Oak Consulting Group

Project 12013

RE: Response to Peer Review Comments  
Village at Bailey's Pond  
Amesbury, Massachusetts

This letter responds to the peer review comments of Gillian T. Davies of the BSC Group as set forth in her letter dated January 29, 2013. In addition to this letter, please find the enclosed:

FIGURE - 2

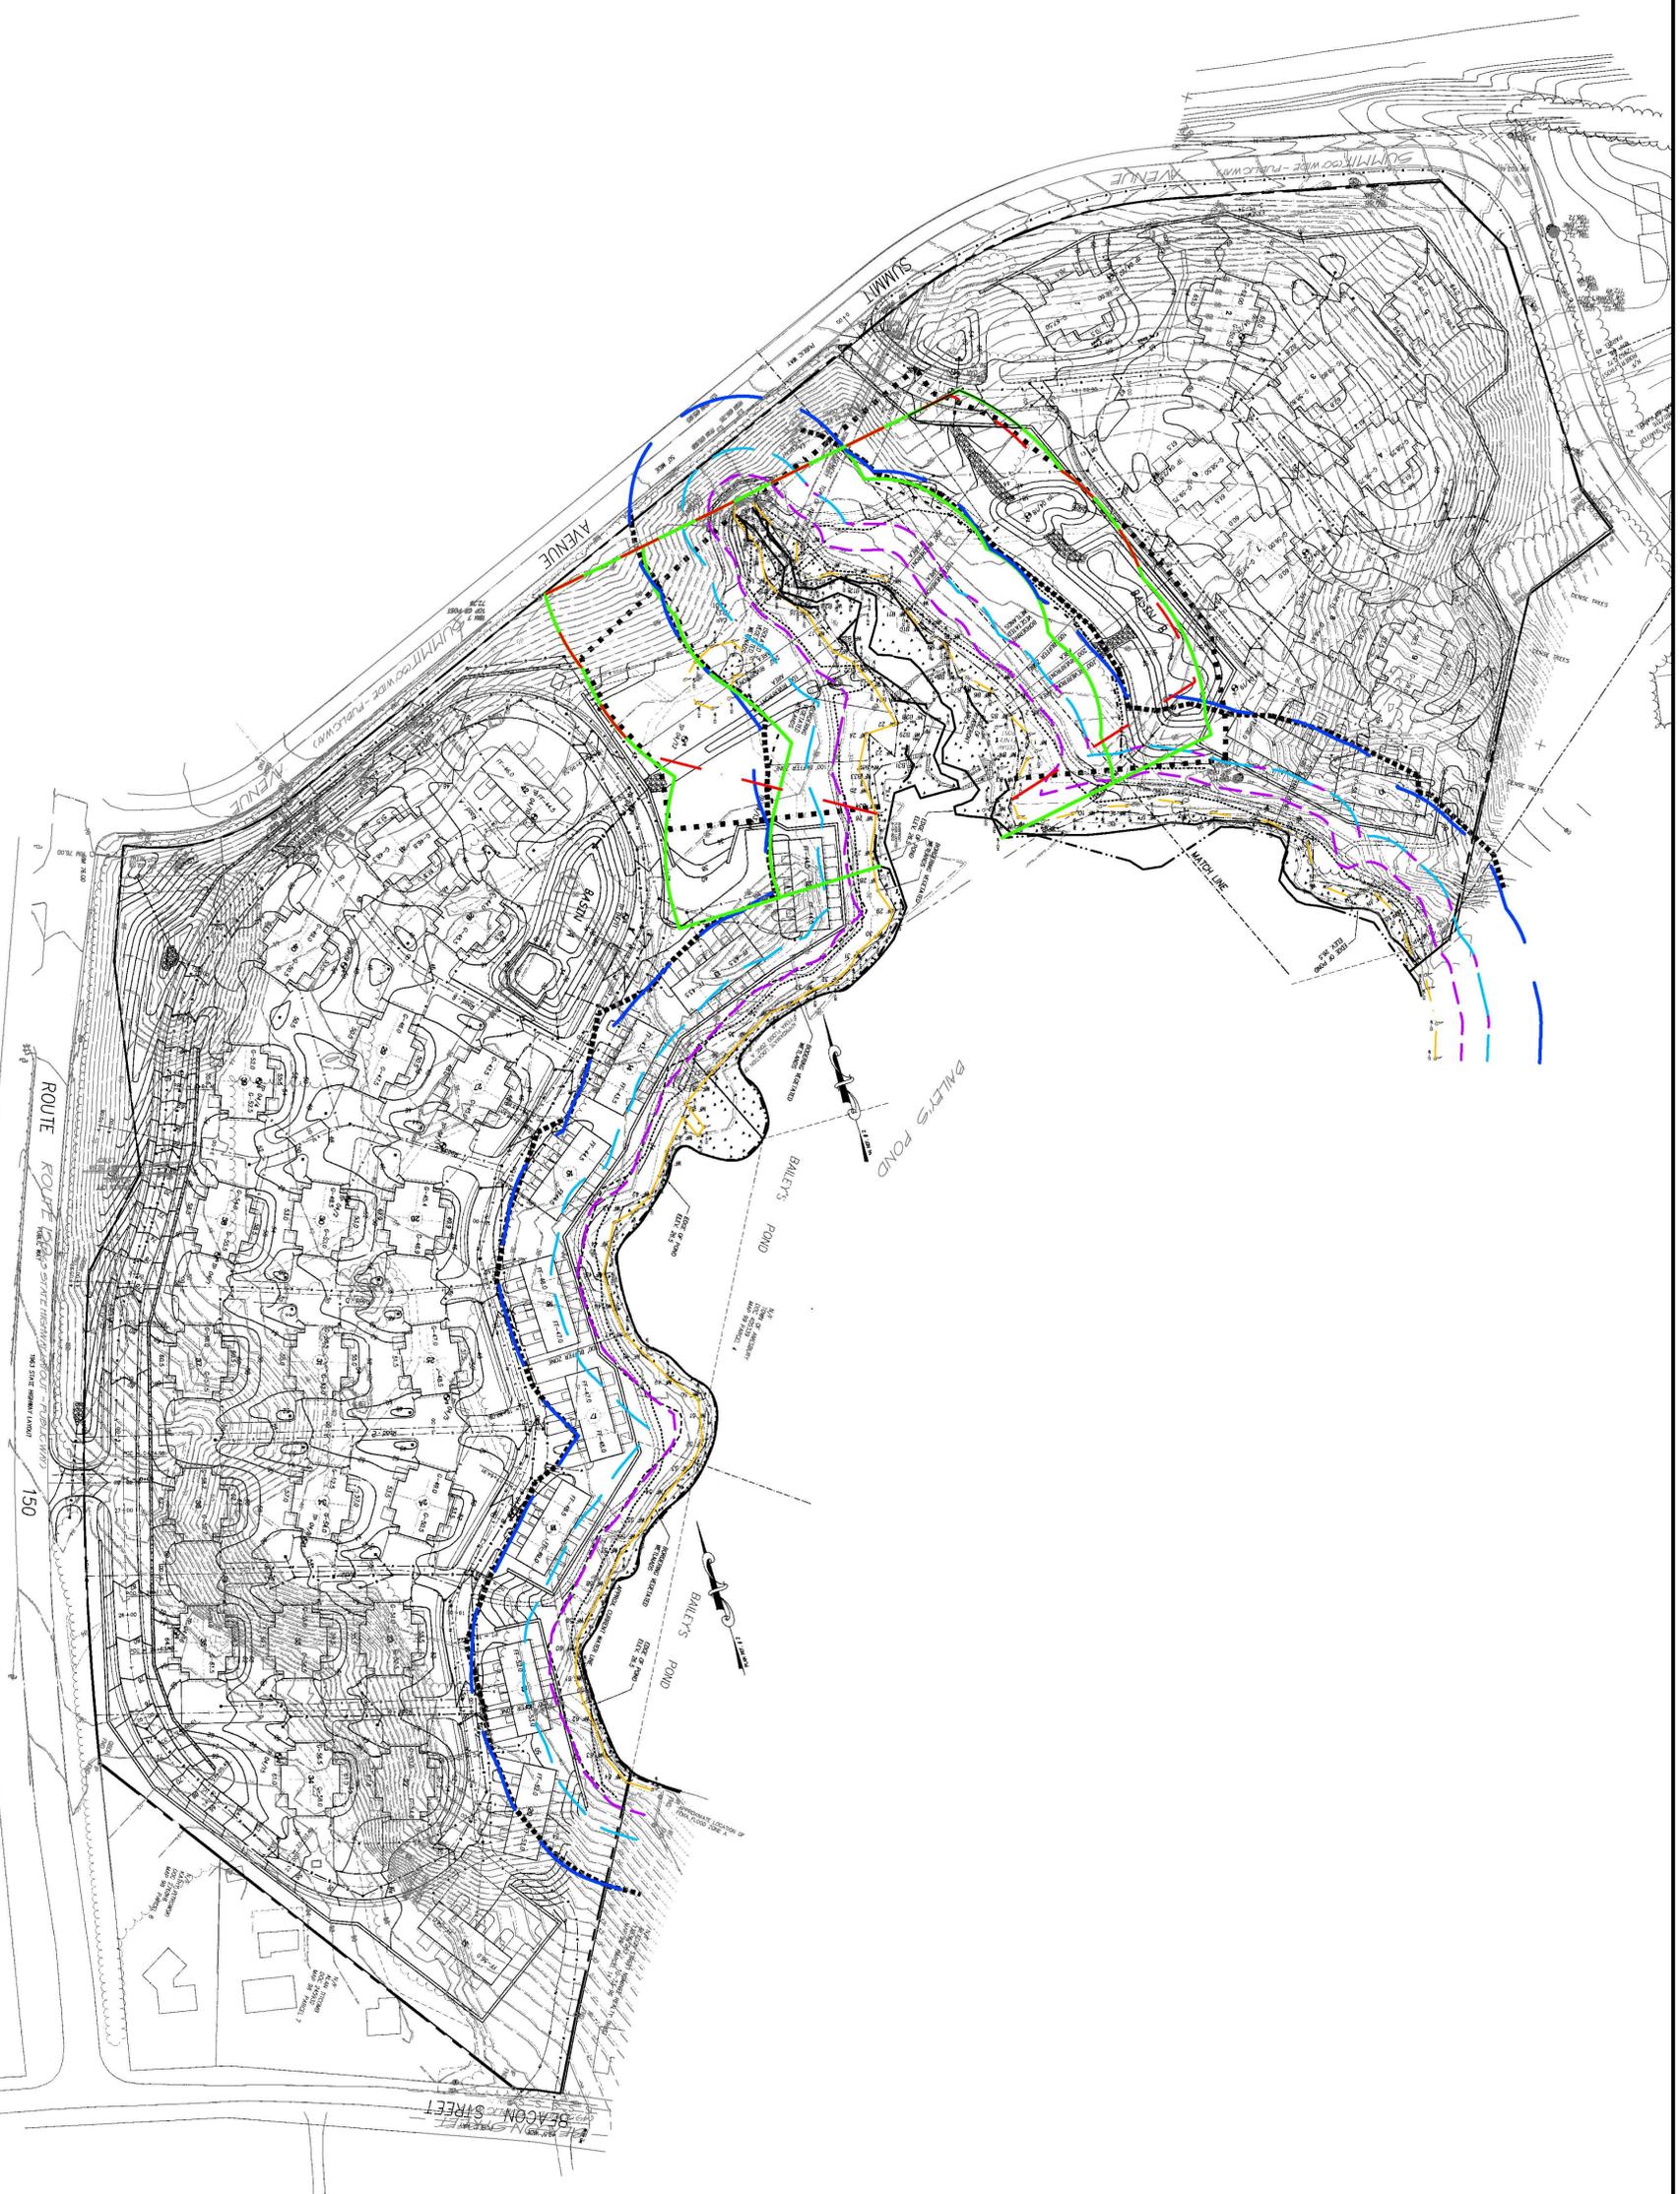
The access road crossed the stream with a number of housing units and impervious surfaces within the Riverfront Area (see Figure 2). That alternative would involve substantially more impact to the Riverfront Area and other resource areas at this site.

**ALTERNATIVE SITE PLAN**

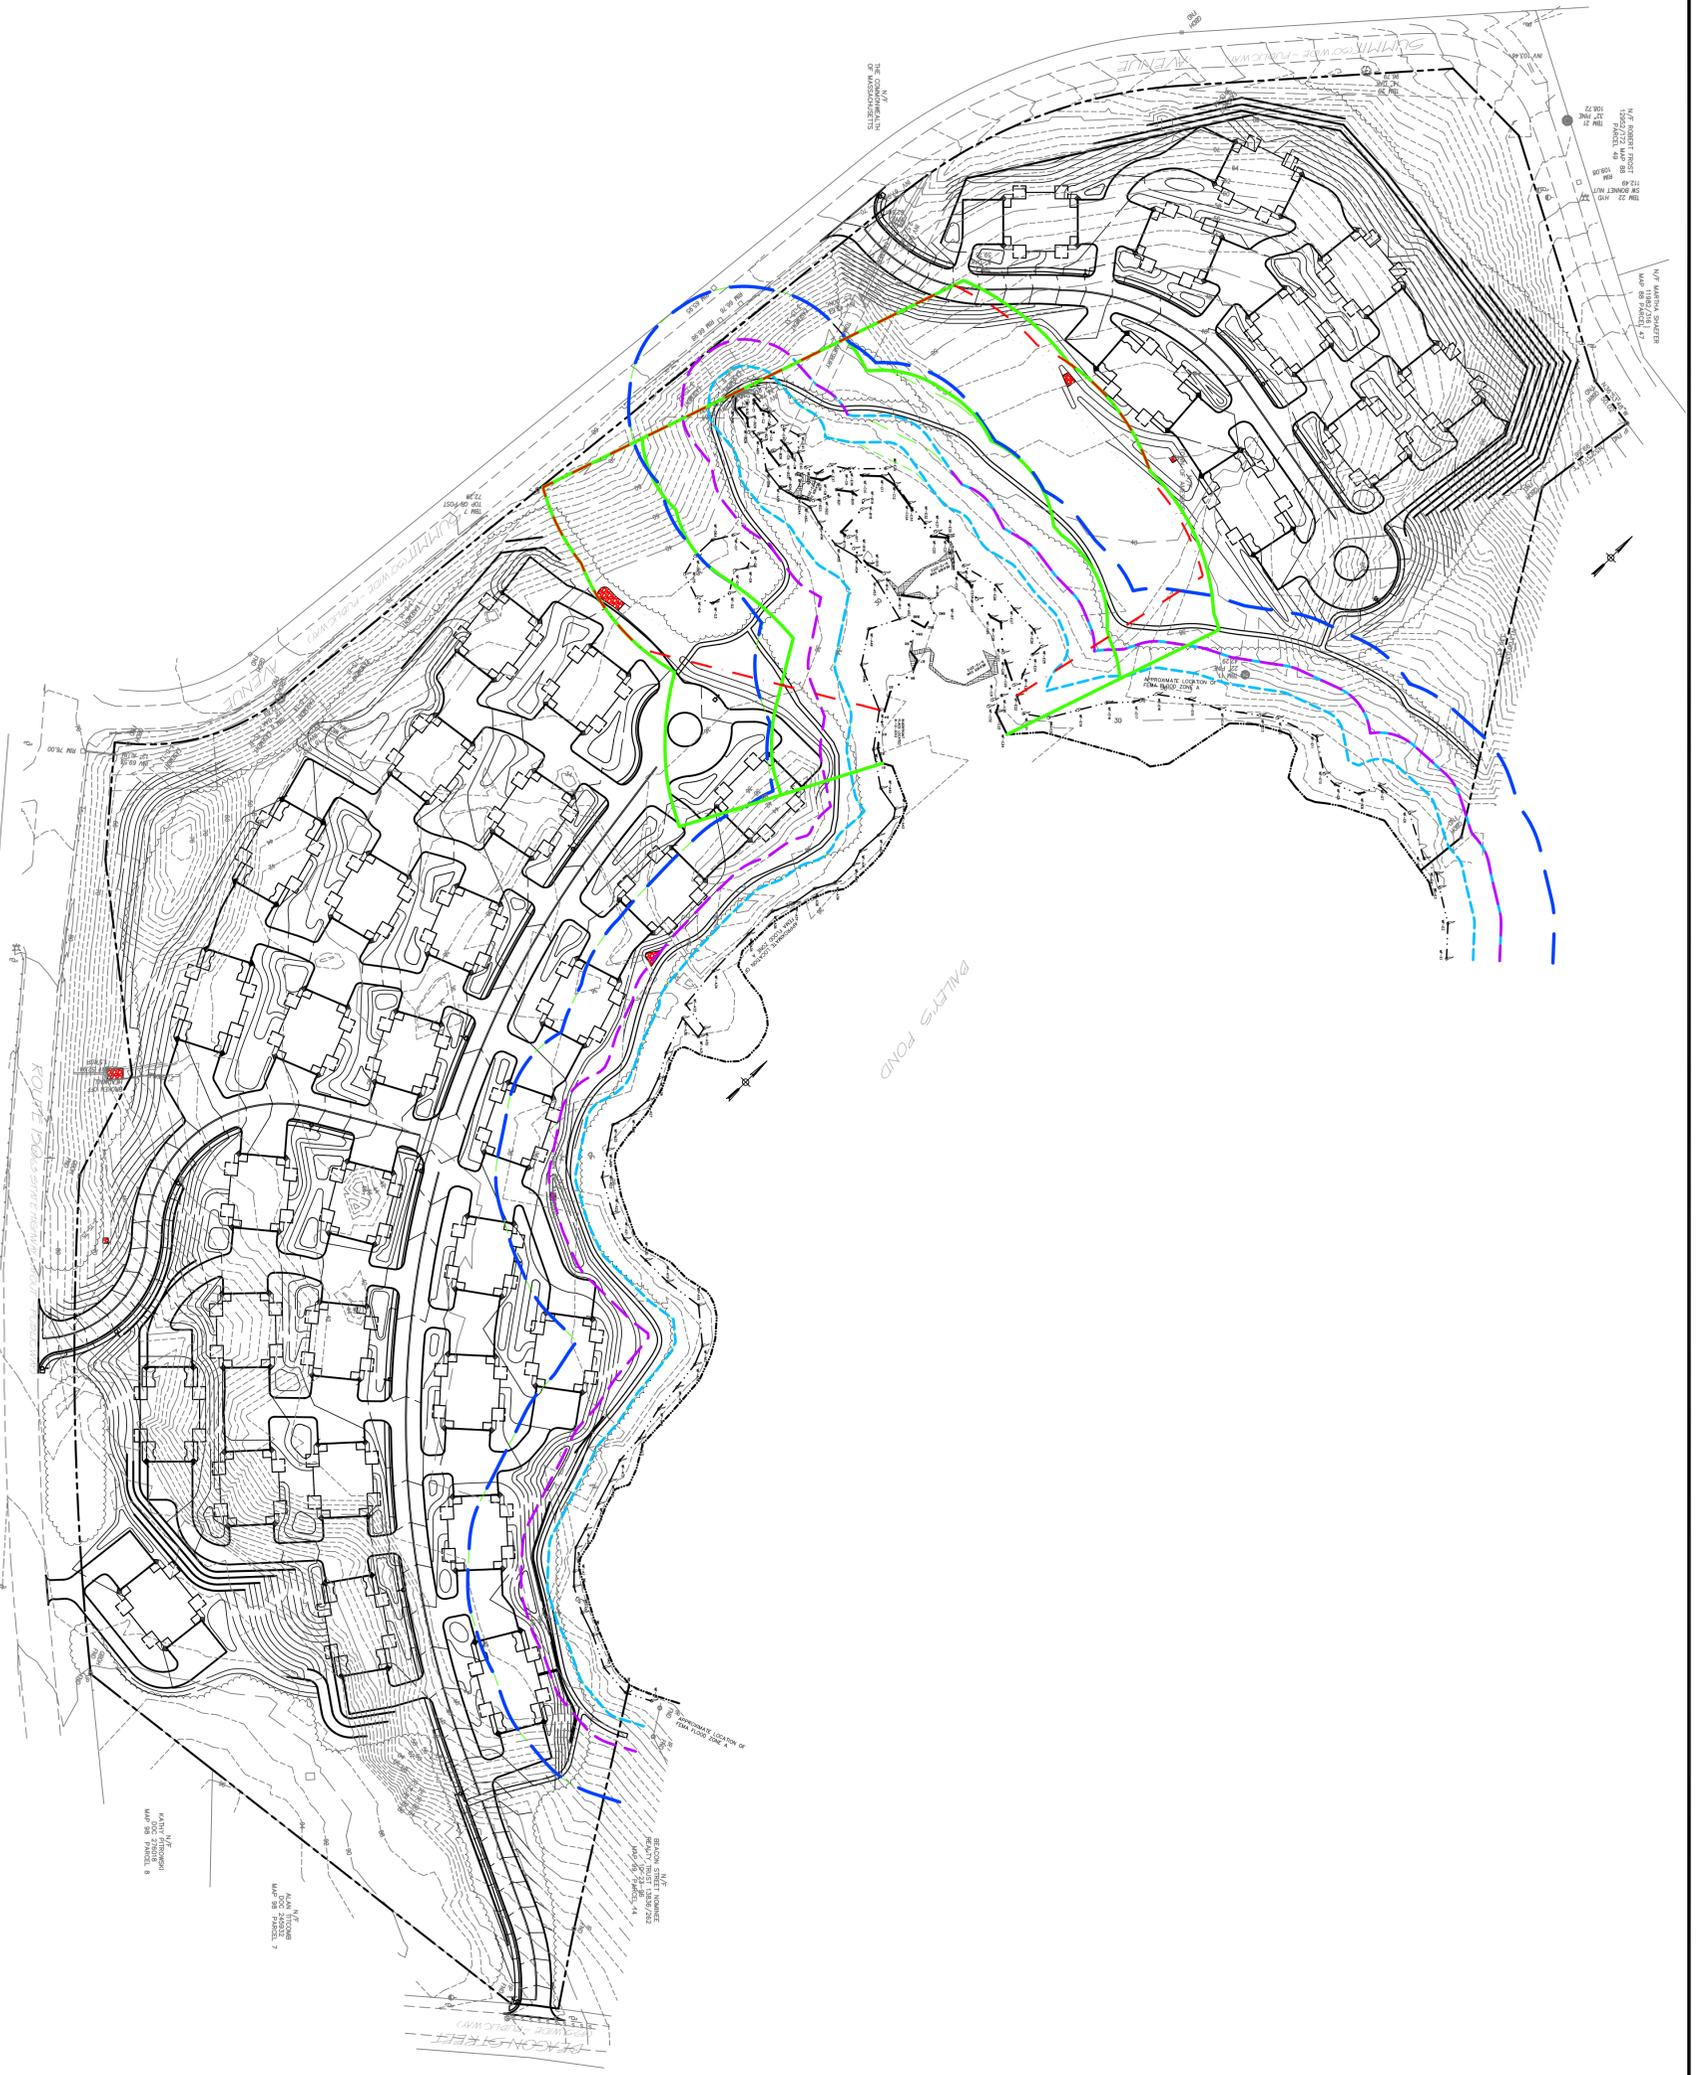
The initial project filing in 2004 consisted of a design layout for 176 units and is shown as Figure 3. This design included portions of several buildings within the 50’ buffer and large retaining walls to be constructed within 50’ of the BVW along almost the entire waterfront. A summary of the impact of this alternative is below:

This design was deemed unacceptable to the Planning Board making it not practicable. Also, it would not result in less adverse impacts than the current proposal.

<table><tr> <td><b>OCG</b></td> <td>Oak Consulting Group</td> <td>SCALE:</td> <td>AS NOTED</td> </tr><tr> <td></td> <td></td> <td>SHEET:</td> <td><b>FIGURE 4</b></td> </tr></table>

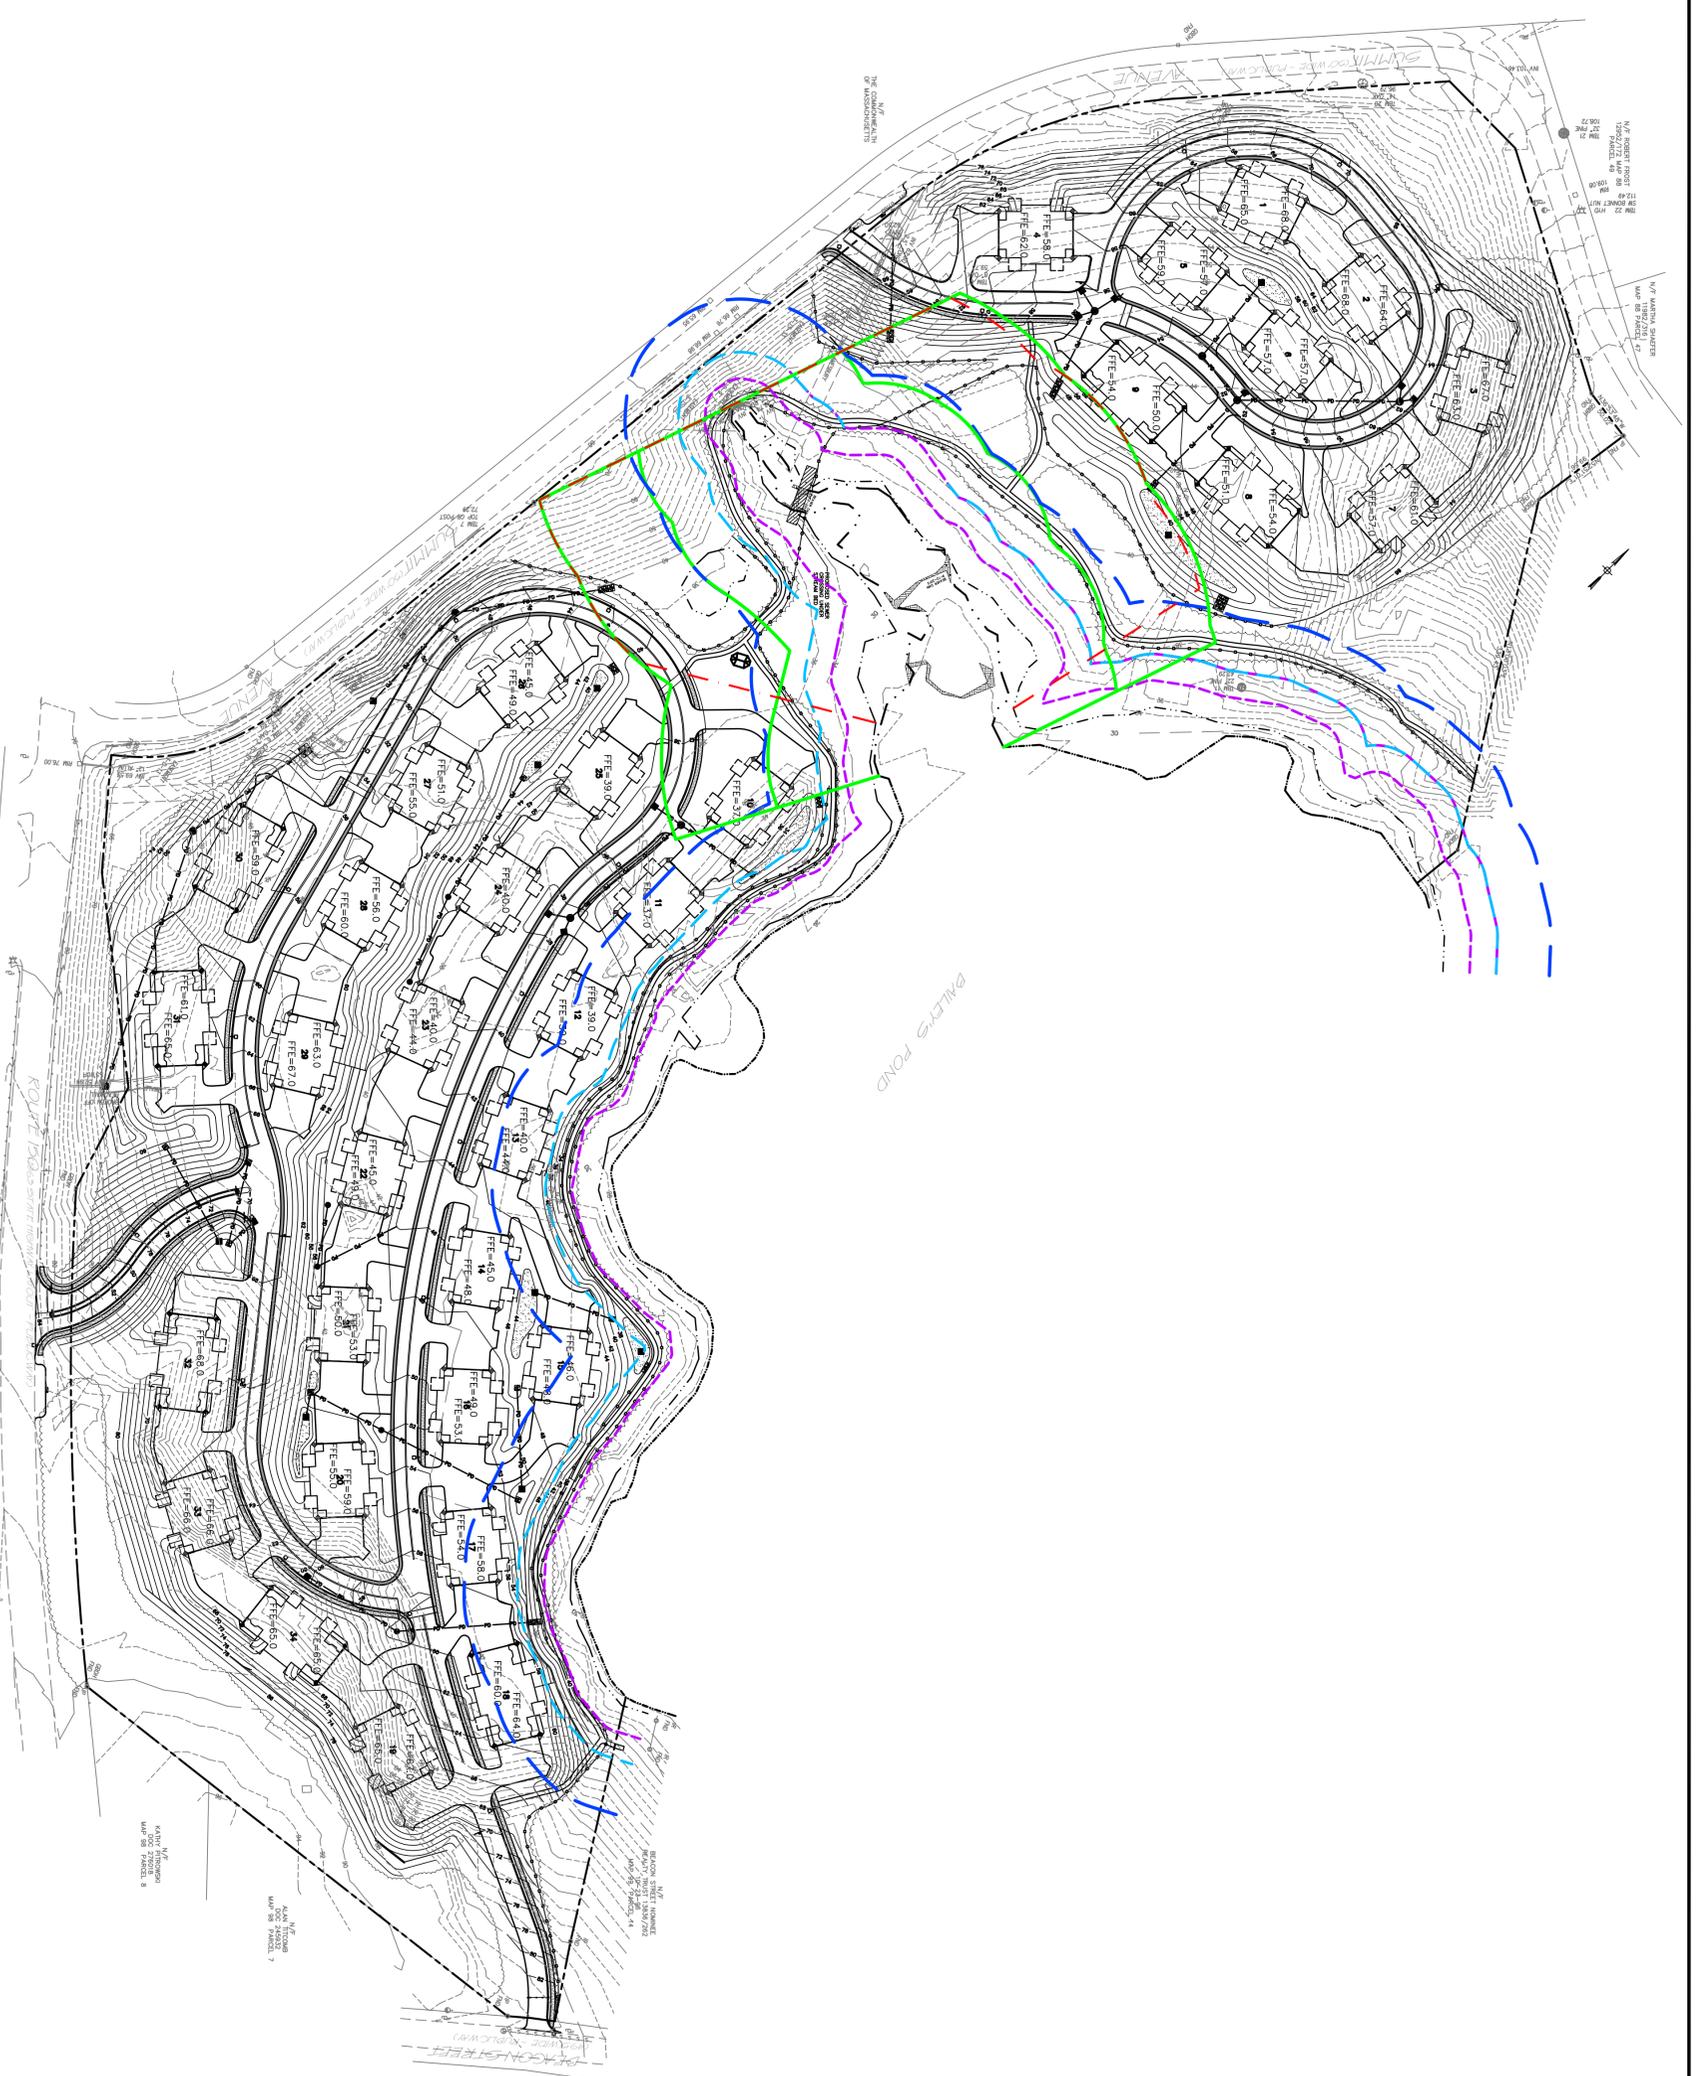
The project was revised in 2010 with a design layout for 148 units and is shown on Figure 4. This design was modeled after a conceptual design prepared by a consultant to the City of Amesbury, Dodson Associates, in June of 2005. This design removed proposed buildings and the large retaining walls along the water front. A summary of the impact of this alternative is below:

The Planning Board, Fire Department and Building Inspector voiced concerns about the site layout including: the use of “dead end” drives limit access; the lack of separation between buildings to allow for vehicle turnaround; the use of many small bio-retention basins in lieu of fewer larger basins at the low points; the overall width of the driveway through the site; and the lack of sidewalks through the site. The Conservation Commission echoed the concerns about the use of multiple small bioretention basins, claiming that there was a history in Amesbury of these not being maintained. As a result the project was deemed unacceptable to the Planning Board and the Conservation Commission making it not practicable.
